**Addendum No. 2
February 16, 2023**

Project: Harrisburg Elementary School #8
Harrisburg, South Dakota
Architecture Incorporated Project #3000

Architect: Architecture Incorporated

CLERESTORY FRAMING- AREA A
 1/8" = 1'-0"

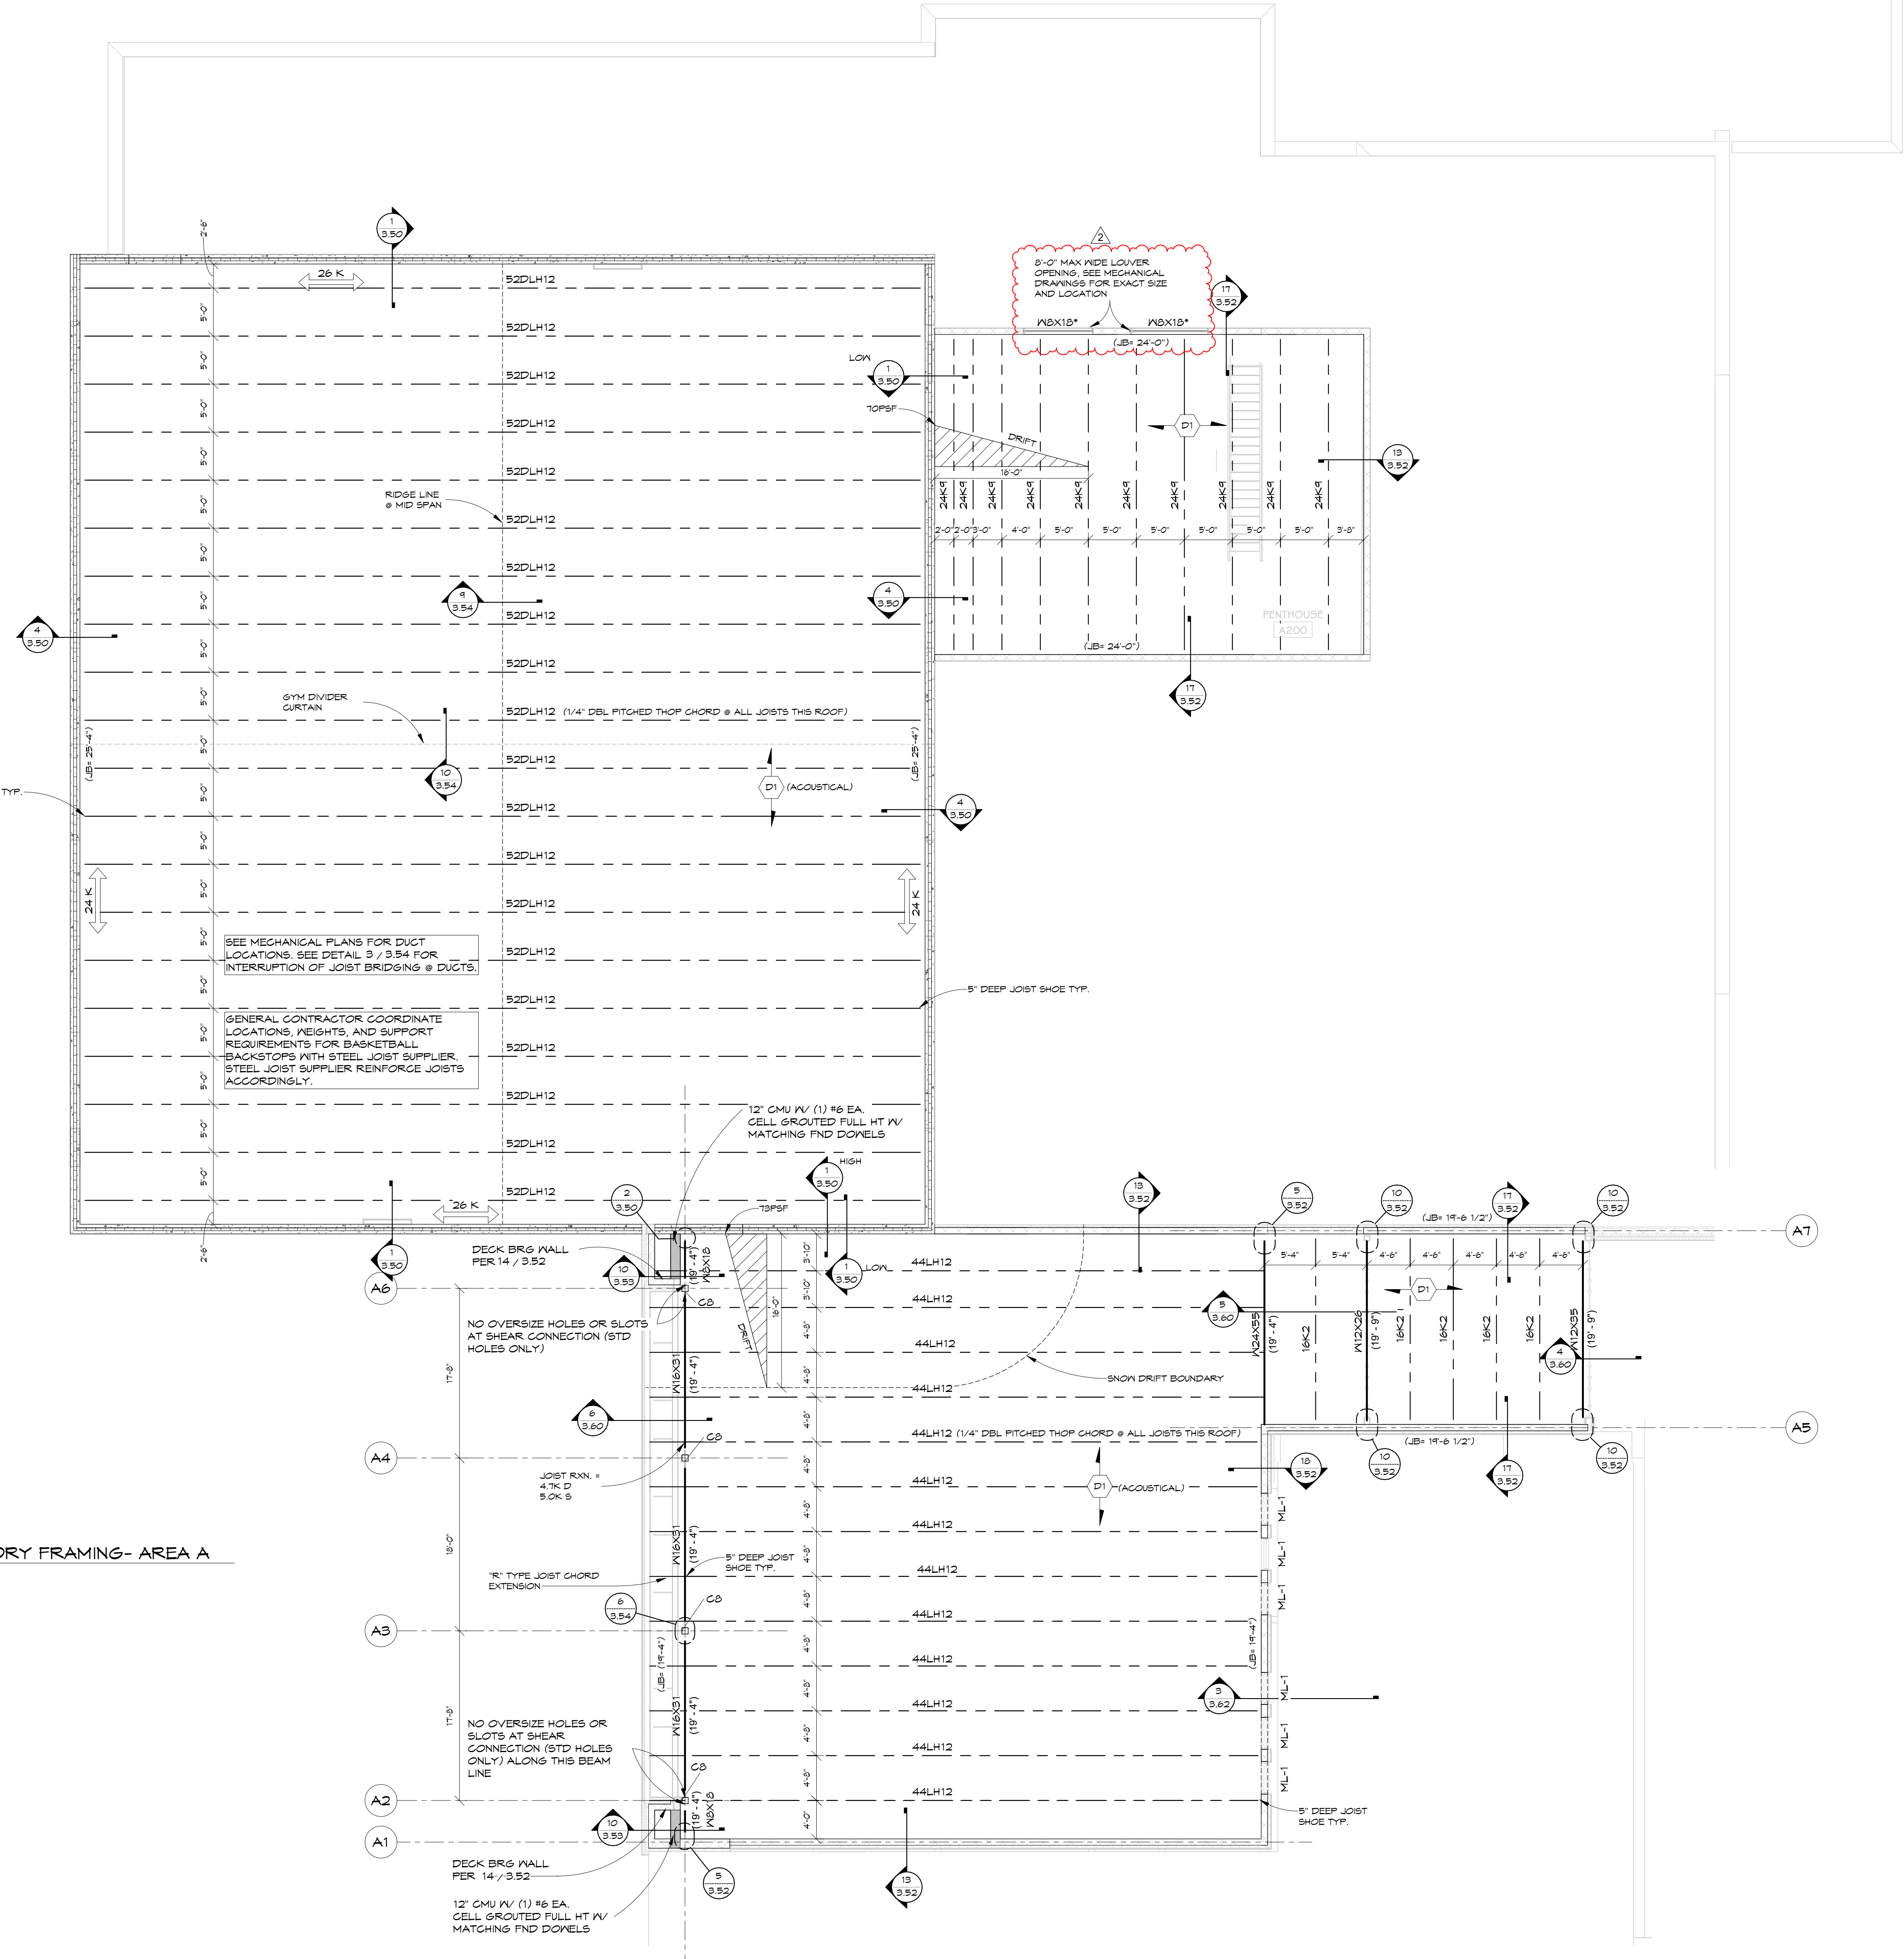
- a) Add steel beam lintels above louver openings in north wall of PENTHOUSE A200 per clouded area on *revised* structural drawing Sheet 3.20-3A, dated 2-16-23, attached to the end of this addendum.

6 AREA C VESTIBULE FRAMING @ STORM SHELTER
1" = 1'-0"

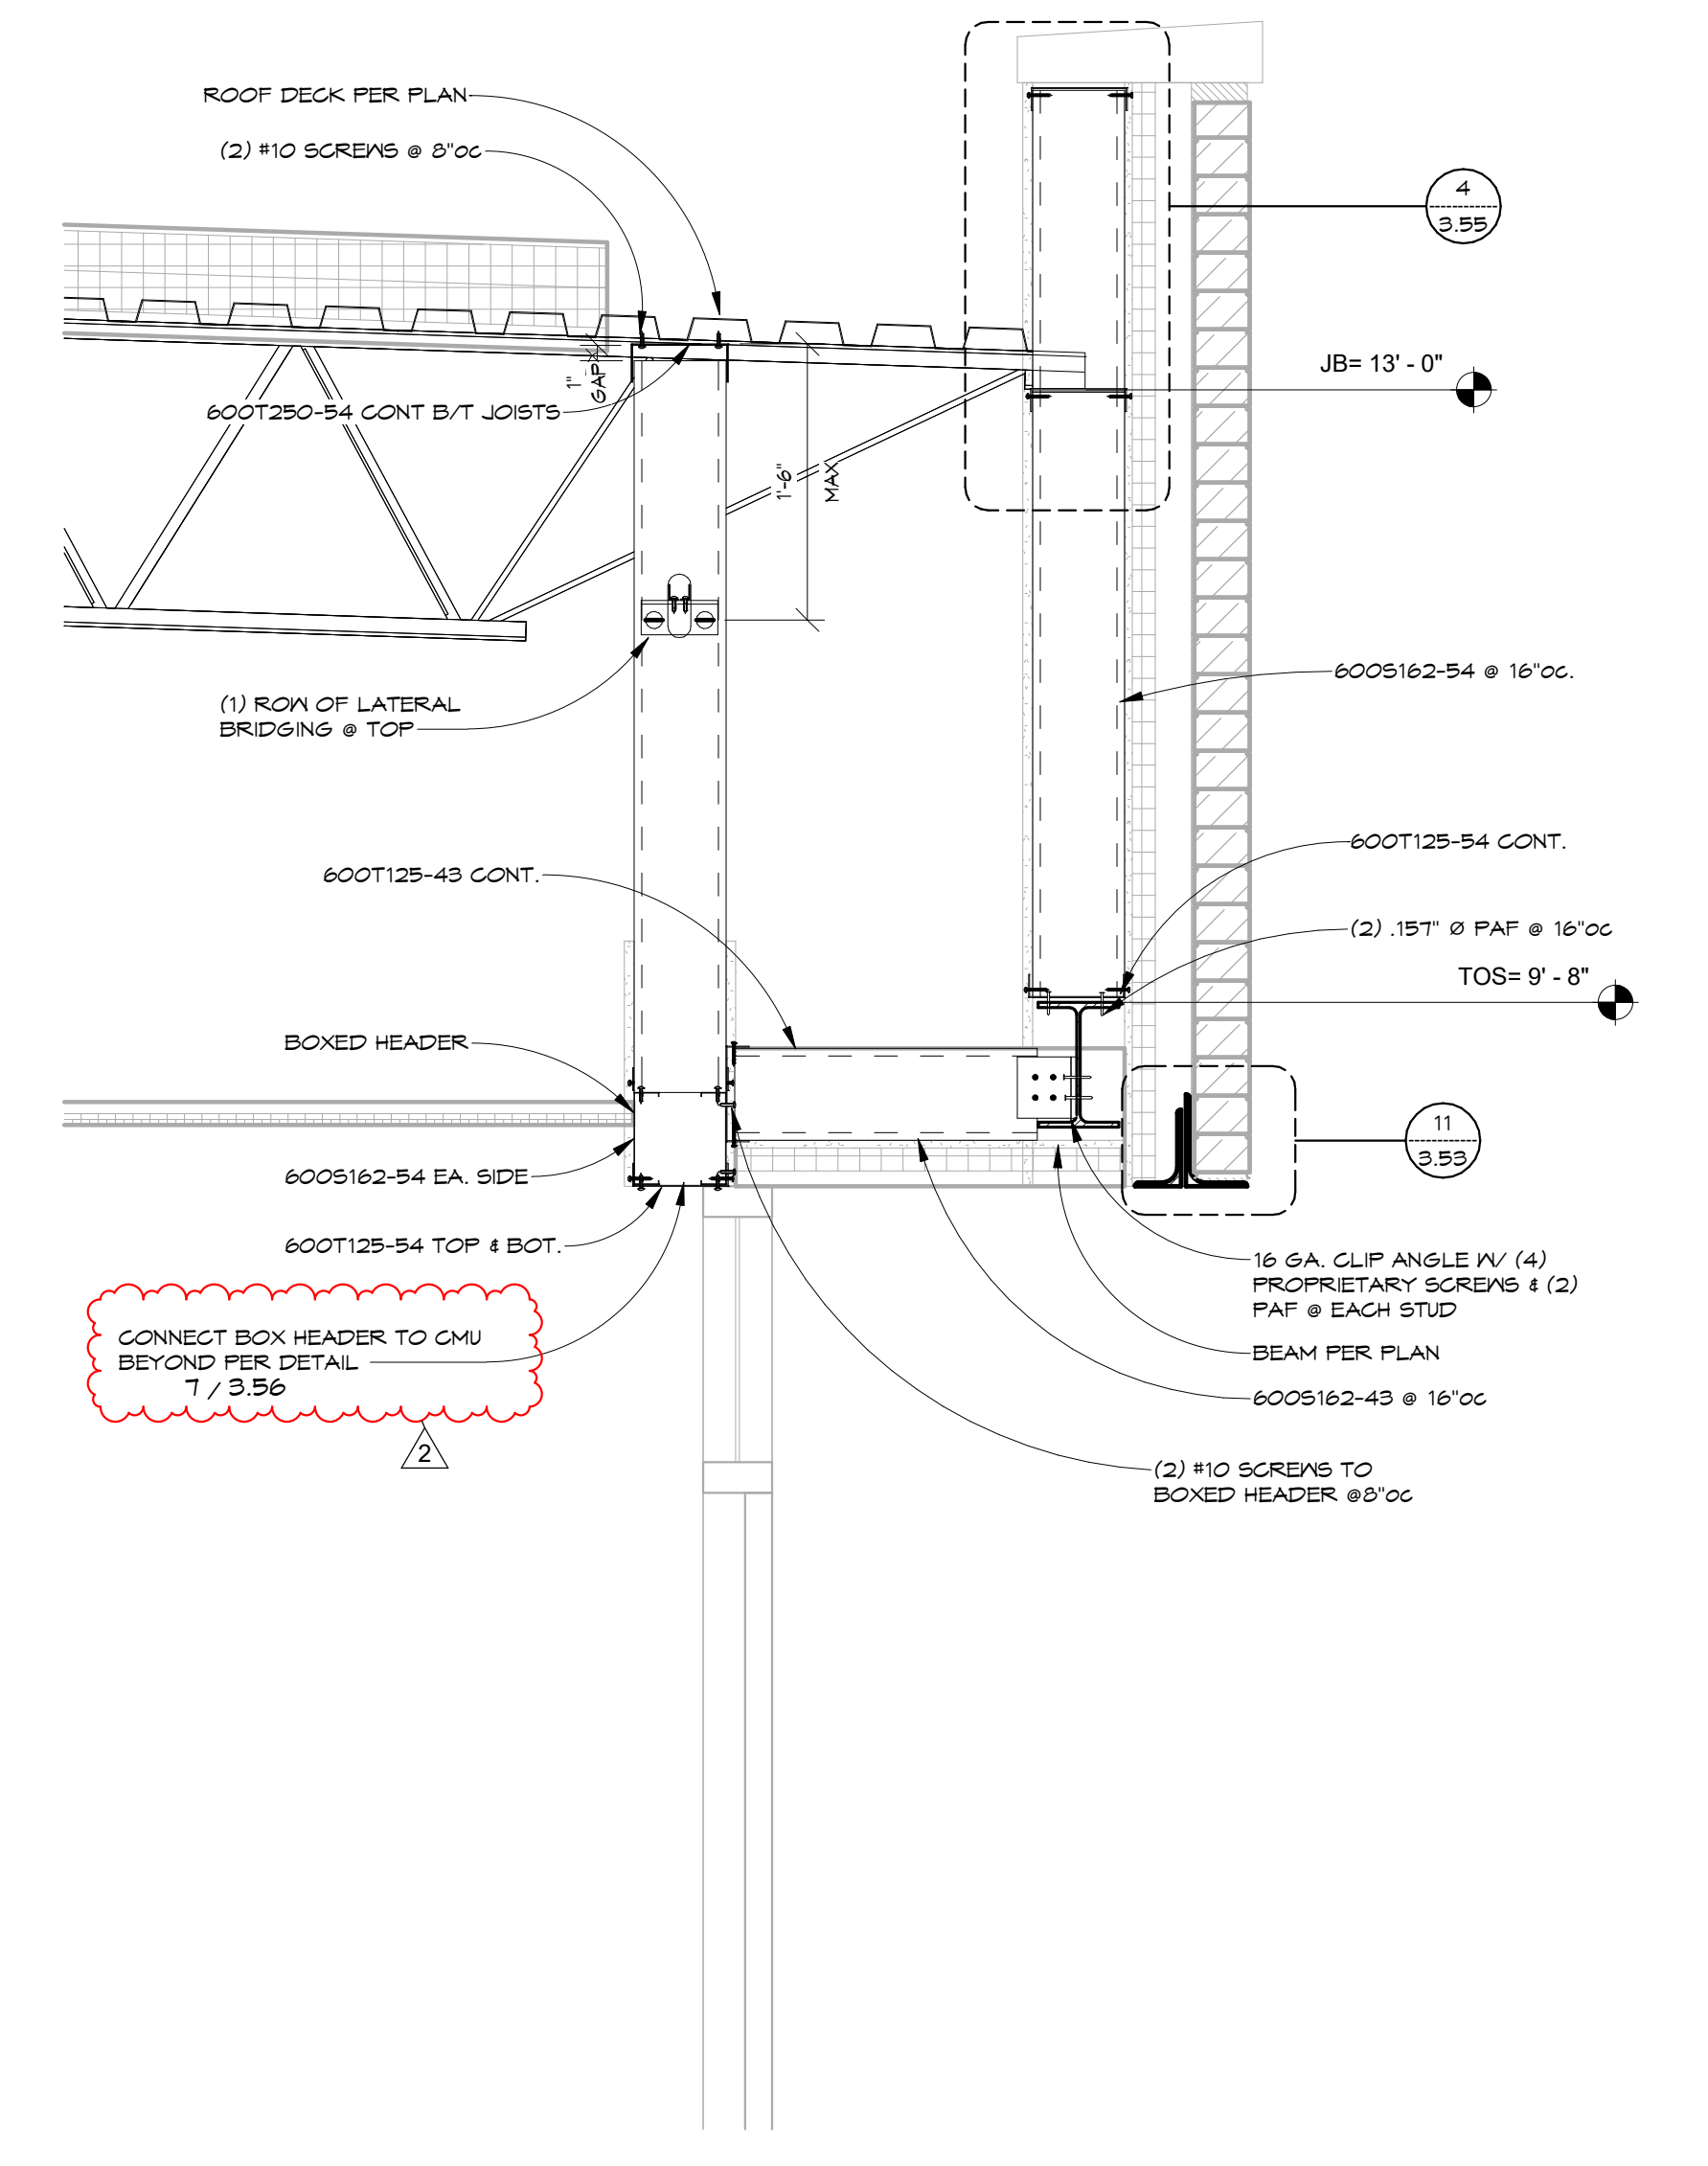
- a) Detail 6: Modify per clouded area on *revised* structural drawing Sheet 3.61, dated 2-16-23, attached to the end of this addendum.

FLOOR PLAN - AREA C
 SCALE: 1/8" = 1'-0"

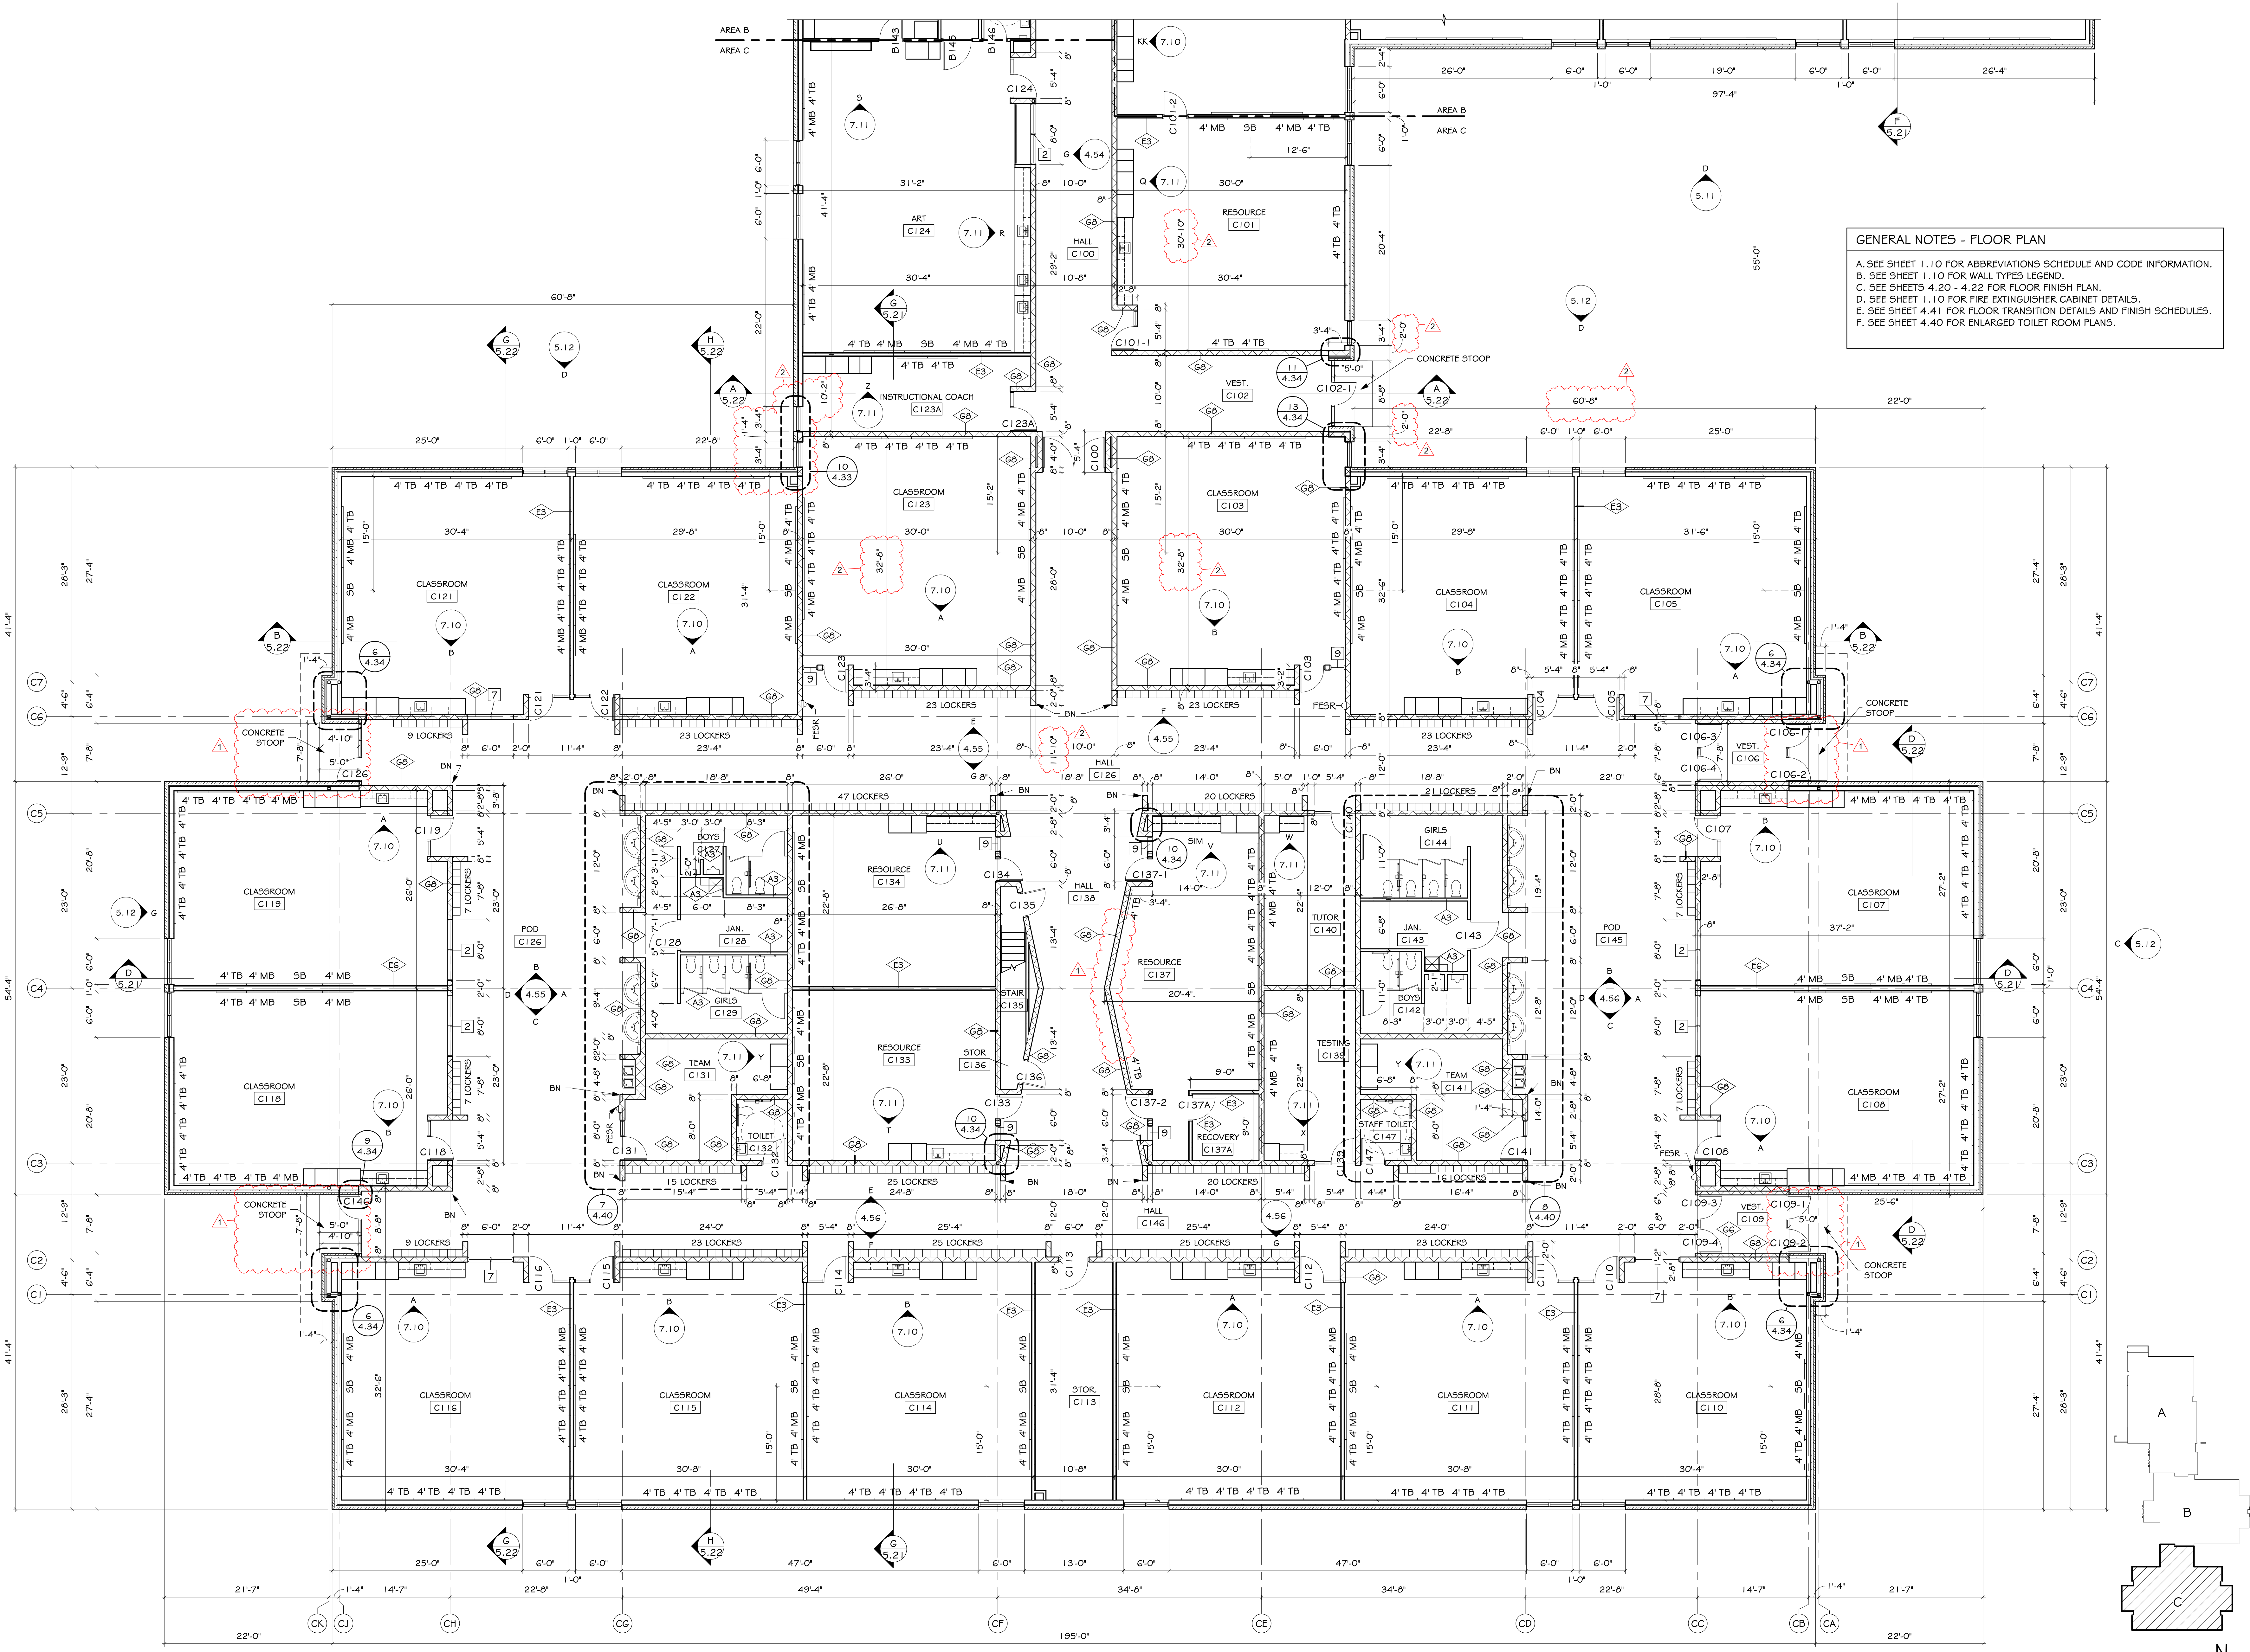
- a) Reference *revised* drawing Sheet 4.13, dated 2-16-23, attached to the end of this addendum for the following modifications:
 - i) Adjust the locations of the north and south CMU walls in Classroom C103 & Classroom C123 as shown.
 - ii) Adjust the location of south CMU wall in Classroom C101.
 - iii) Adjust the location of the storm window in C123; reference revised Sheet 4.33 for modified jamb details.
 - iv) Overall building dimension has been added along the north exterior wall of Classroom C104 & Classroom C105.
